Our ref: PREFR/23-000018
Your ref: Guanockgate Road Gorefield
Date: 08/09/2023
Doc no: 201109628
Officer: Jessica Gething
E Mail: Jessica.Gething@cambridgeshire.gov.uk

Proposal: New solar photovoltaic (PV) farm at Land east of Guanockgate Road, Gorefield, Cambridgeshire PE13 4PL

Figure 2: Surface Water Flood Risk Mapping (Source: GOV.UK)

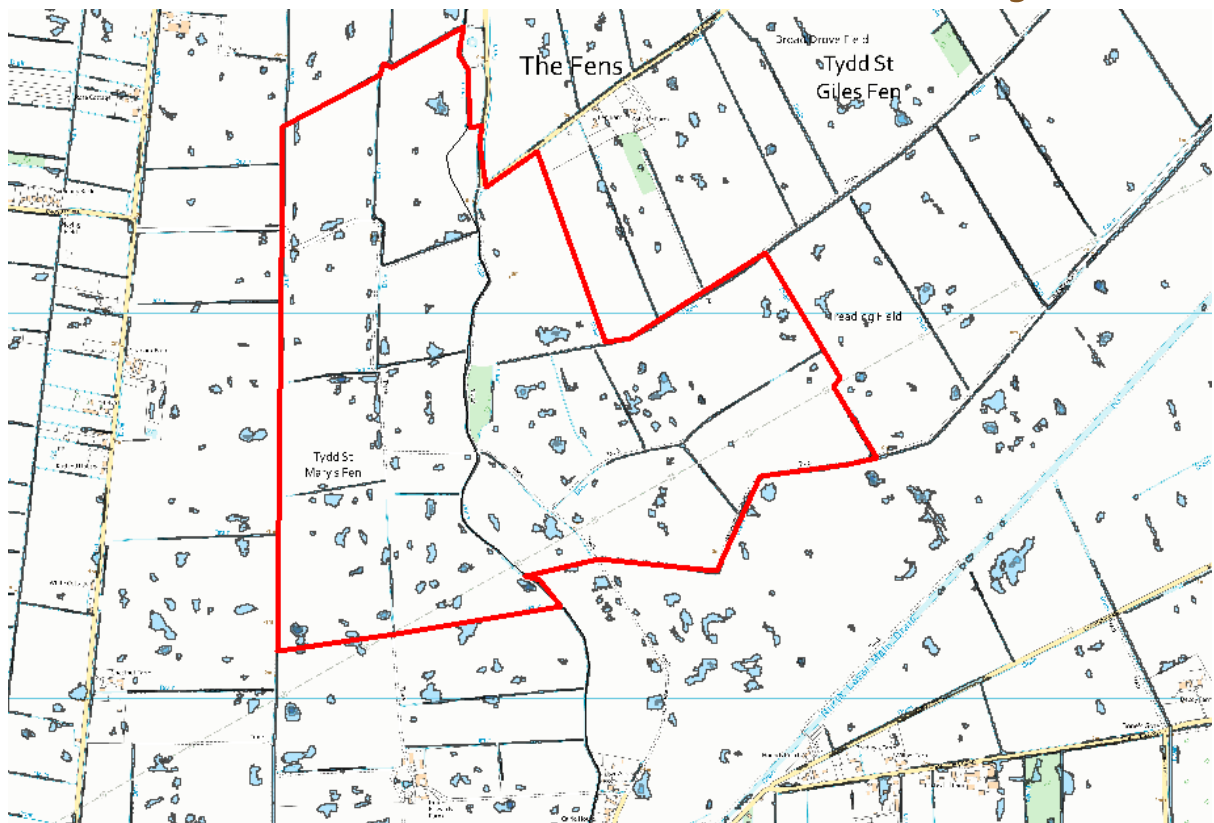
The surface water flood risk at the site can be seen in Figure 2, which shows that there are areas of low surface water flood risk. These do not appear to be overland flow paths and are likely due to local topographical depressions.
